1 July 2025

Our Ref: 240065-M
Reissue of: 240065-J

Geotechnical Response to Council Queries Delmore Residential Development

S92 Response Slope Stability Summary of Results

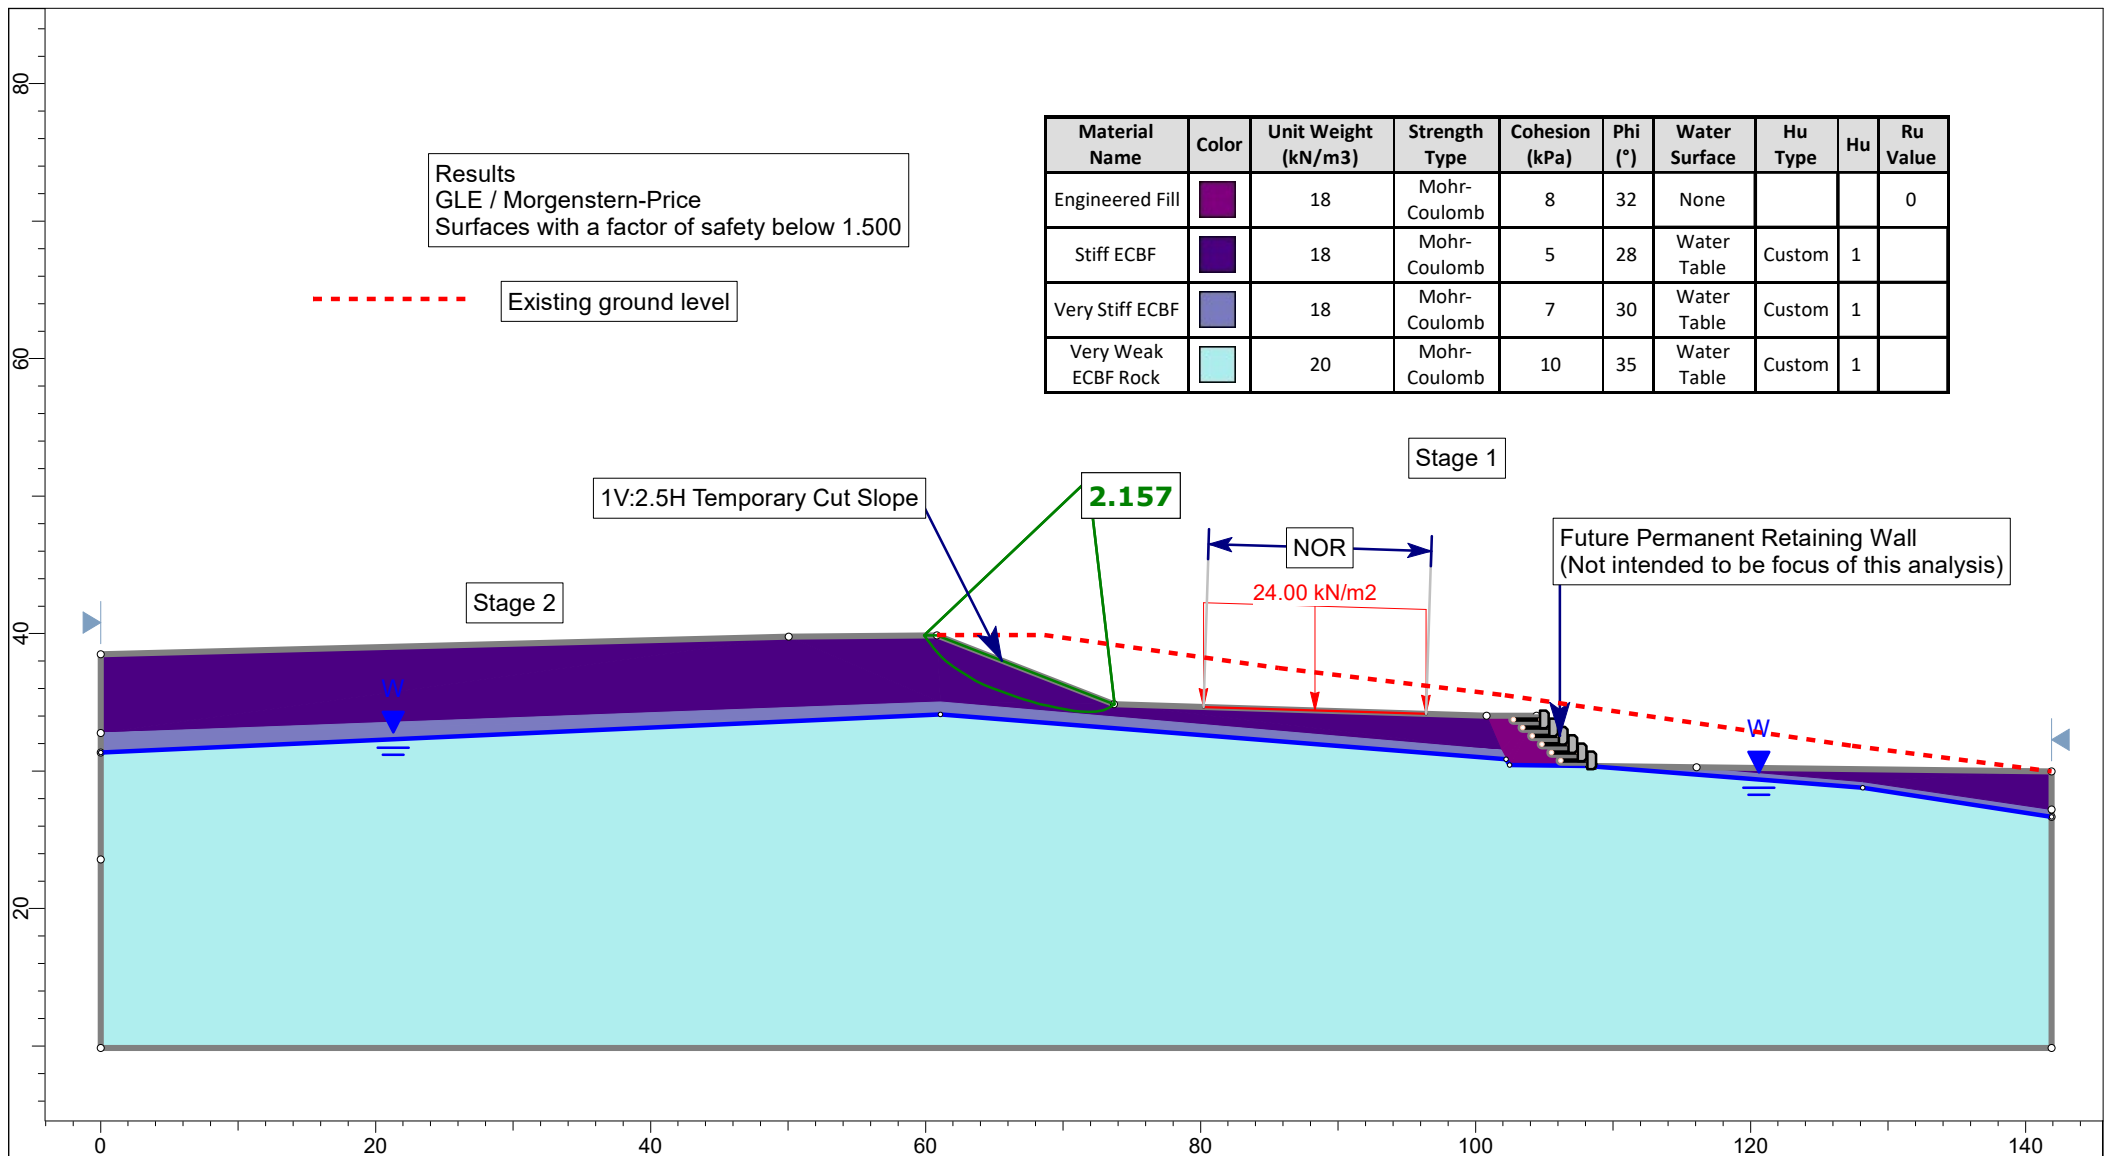
Stage 1 and 2 - Expected surcharges such as new dwellings, roads etc., have not been applied for the proposed development condition.

Soil parameters presented in Table 7 does not align with modelled parameters (e.g. unit weight of Medium Dense ECBF in table is 18 kN/m³ but in the Proposed GL (RHS) – Section V for Stage 2 seismic is 20 kN/m³). Discrepancies should be justified or revised.

The stability analysis assumes that the fill material is completely dry. However, porewater pressure could potentially develop within the fill, particularly in the event of drainage system failure. Therefore, the potential effects of porewater pressure should be considered in the stability analysis to ensure a more conservative and realistic assessment.

Stage 2 only - It would be beneficial to provide a stability analysis for Section AD, considering potential theoretical slip surfaces from left to right.

We note that only proposed slope profiles have been assessed. For assessment against E12.8.2(1)(i) (the extent of risks associated with natural hazards and whether the risks can be reduced or not increased) please provide quantitative slope stability models and assessment for the existing condition for review.

It would be beneficial to provide a stability analysis for Section R, considering potential theoretical slip surfaces from right to left to capture the other side of the MSE slope and palisade wall.

Because many of the following responses also required slope stability reanalysis, a table summarising relevant slope values for all query responses is also appended to help compare new and previous results.

Response (1)11
Slope Stability Outputs
Stage 1-2 Temporary Batter

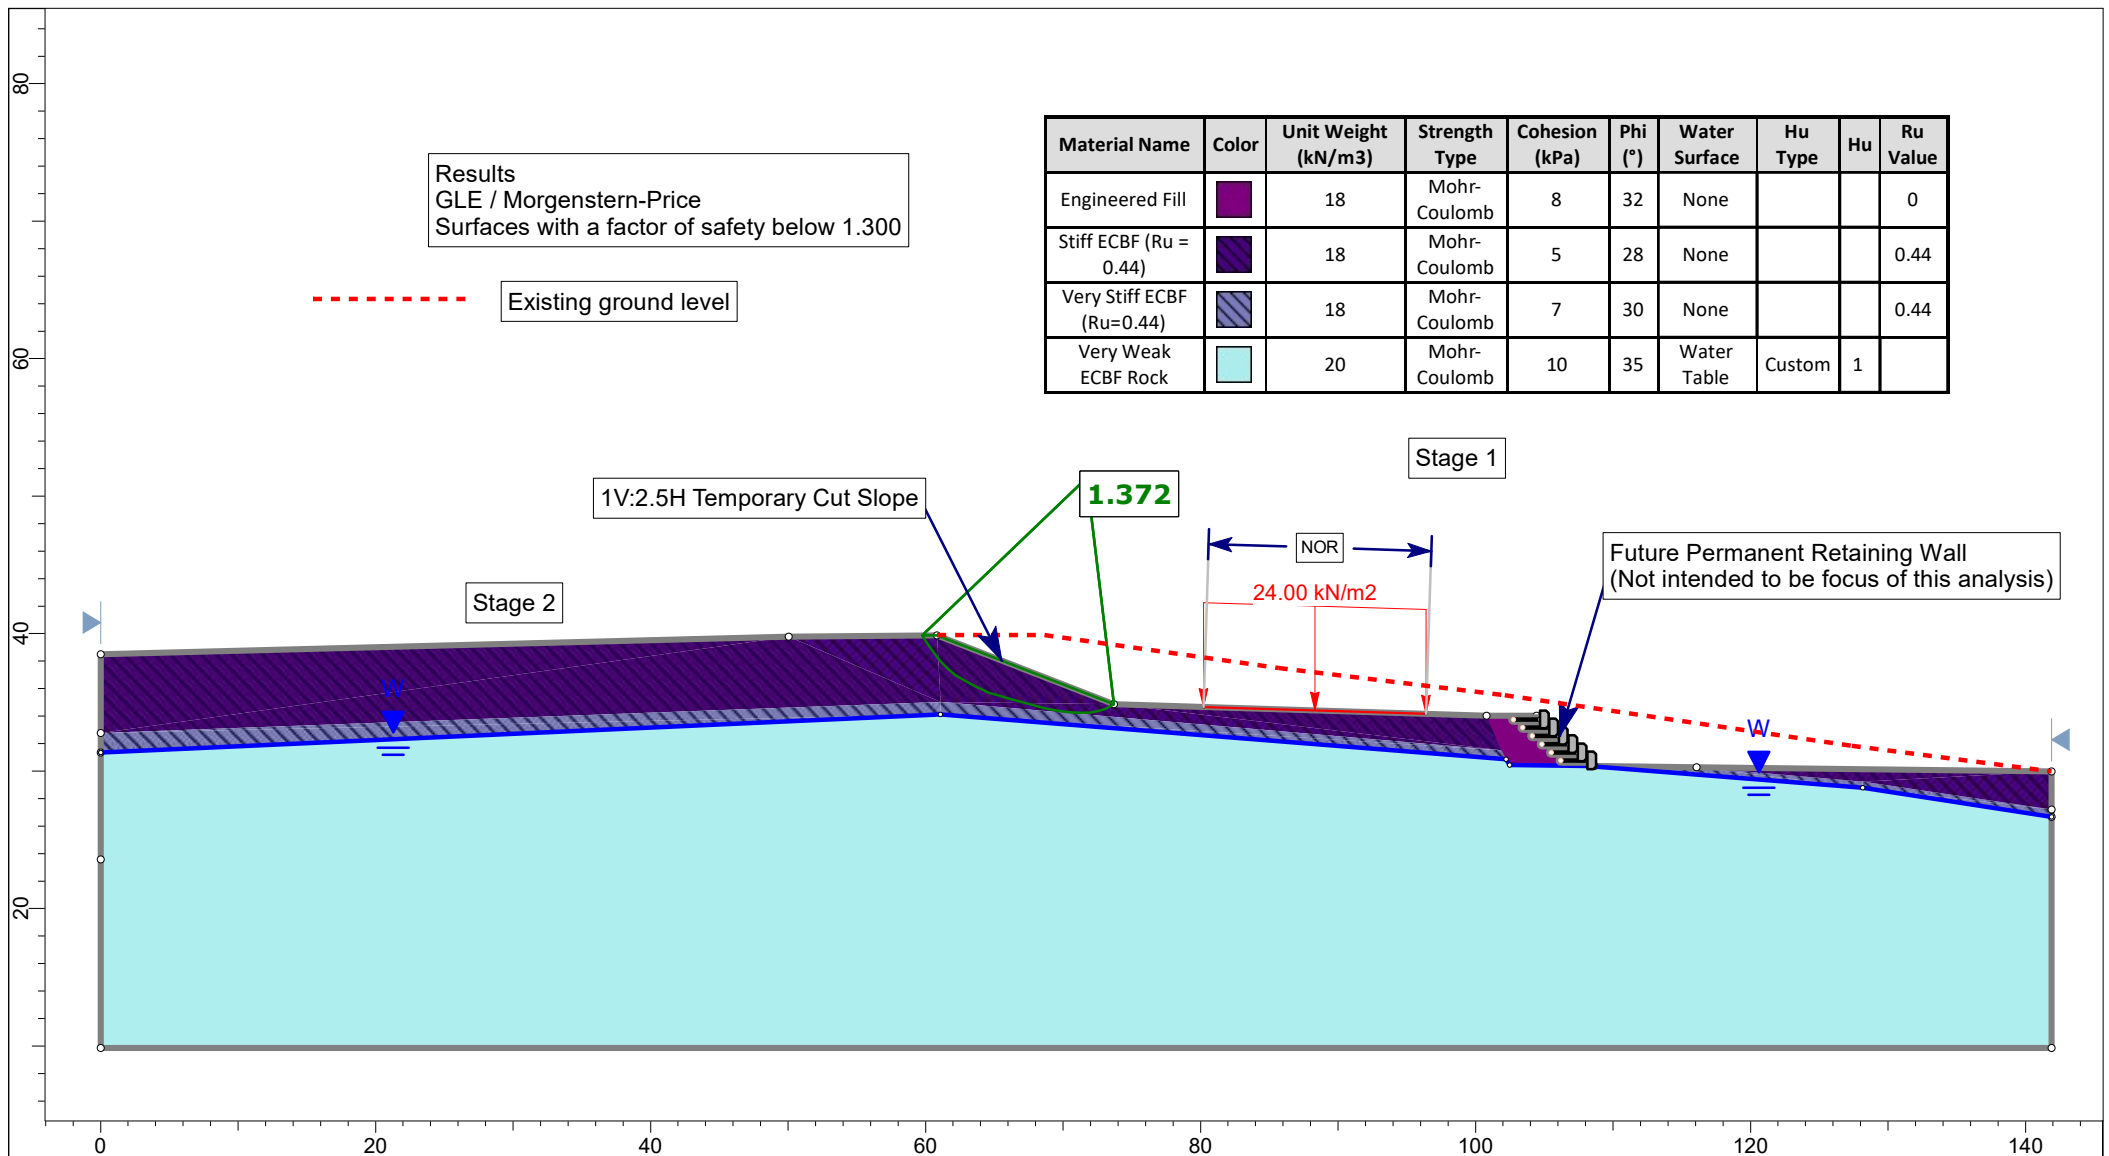
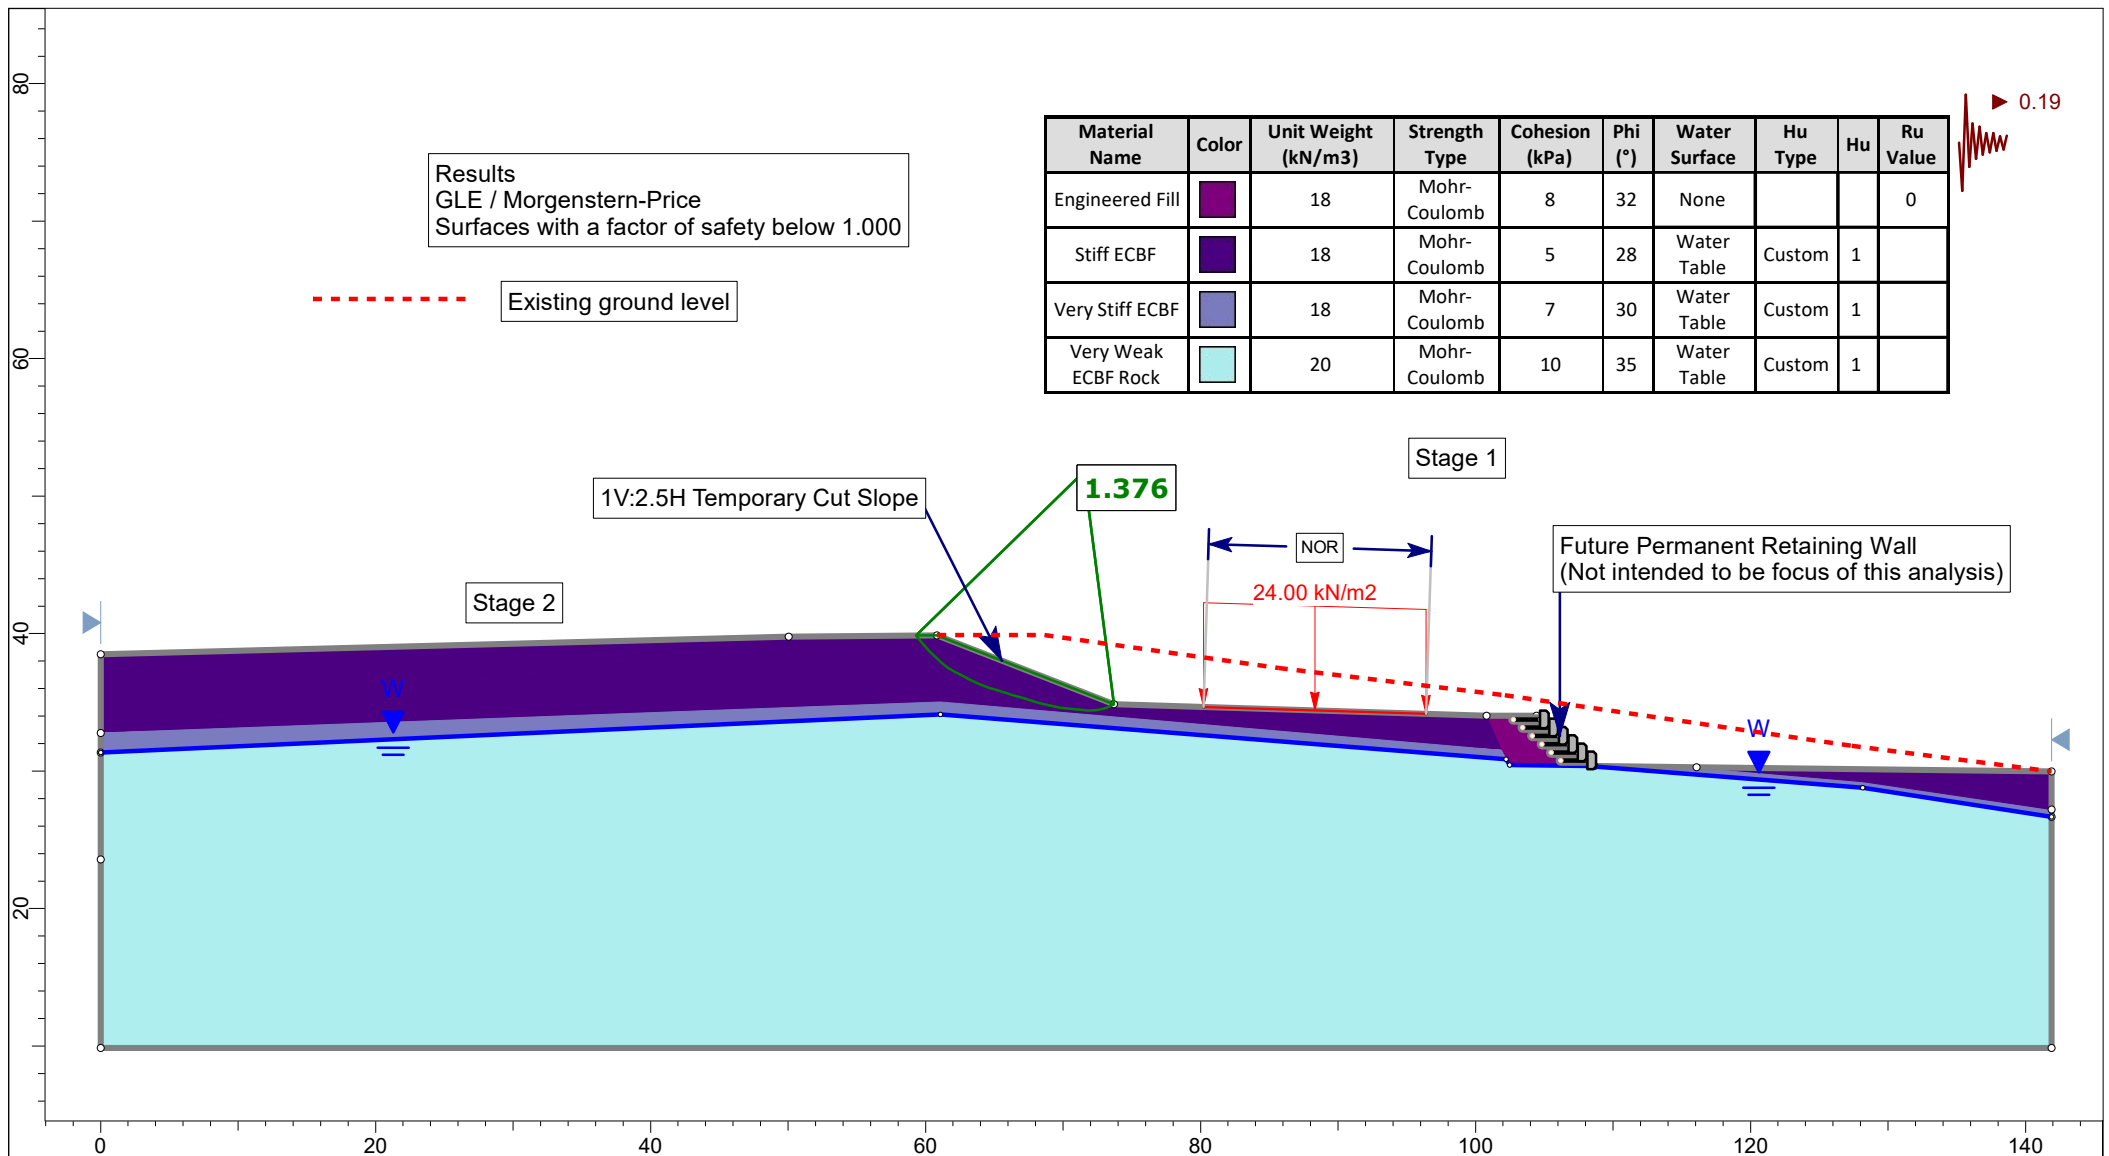
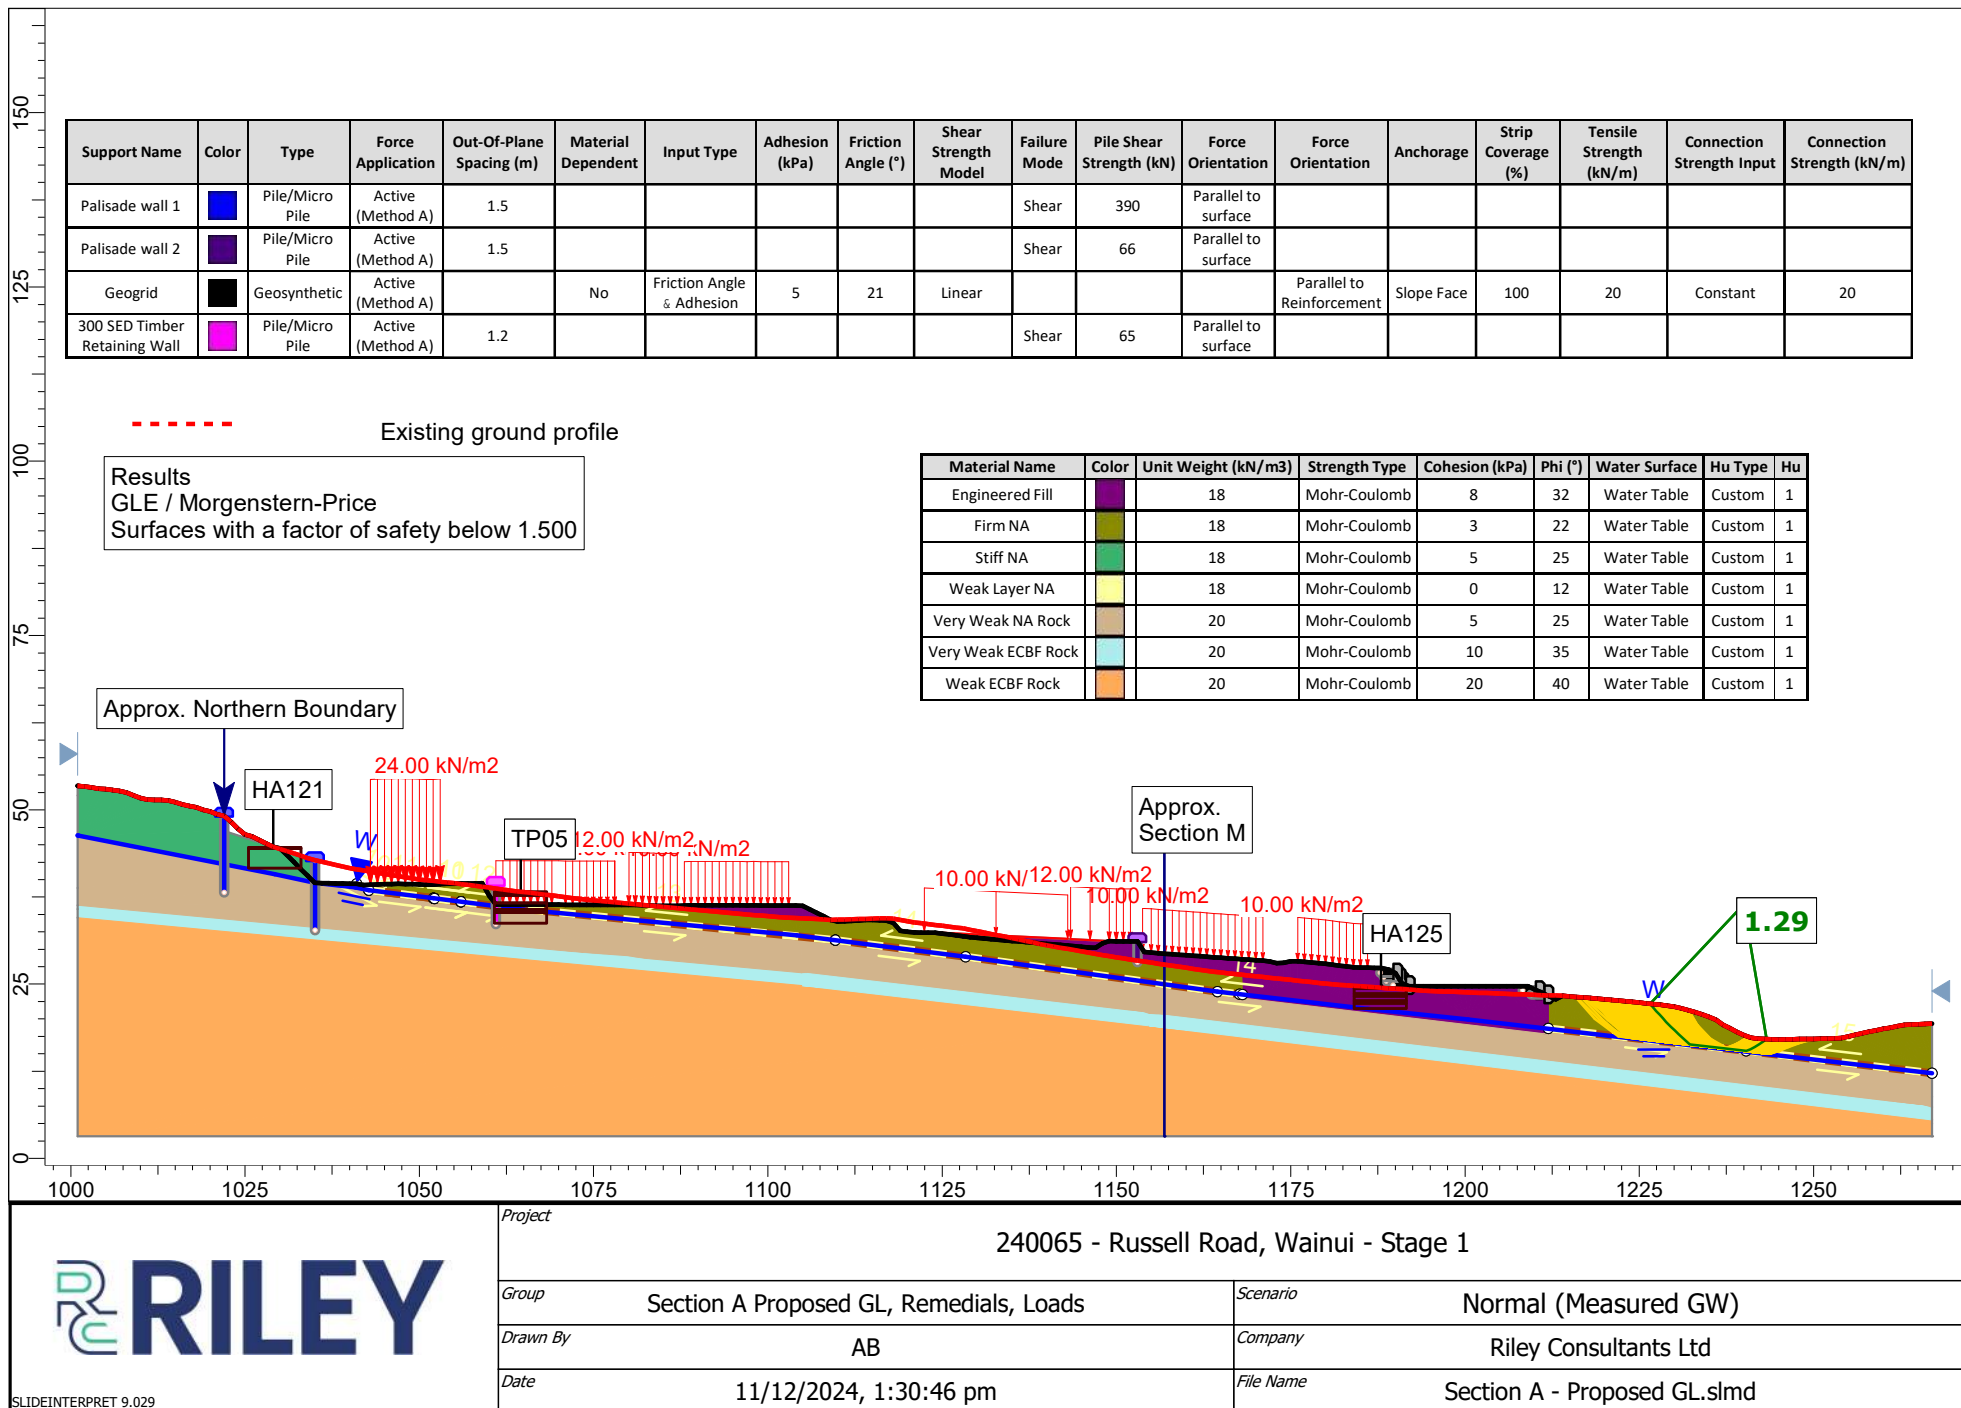
It is noted that earthworks and retaining are proposed to be staged, details should be provided to clarify how stability will be maintained between Stages 1 and 2 and substages (particularly where earthworks and retaining are proposed at the stage boundaries).

The earthworks boundary between Stages 1 and 2 is temporarily proposed to comprise a 1(V):2.5(H) cut batter. This temporary batter will be formed during Stage 1 cut to fill earthworks and later removed as part of the proposed Stage 2 cut. Riley has undertaken additional stability analysis on a representative section of this temporary slope under normal and extreme groundwater conditions, and under Ultimate Limit State (ULS) seismic conditions. The results indicate that the Factor of Safety (FoS) values available for this temporary slope achieve the minimum outlined in the Auckland Council Code of Practice for Land Development and Subdivision (CoP). Outputs from the slope stability analysis programme SLIDE2 are appended to this letter.
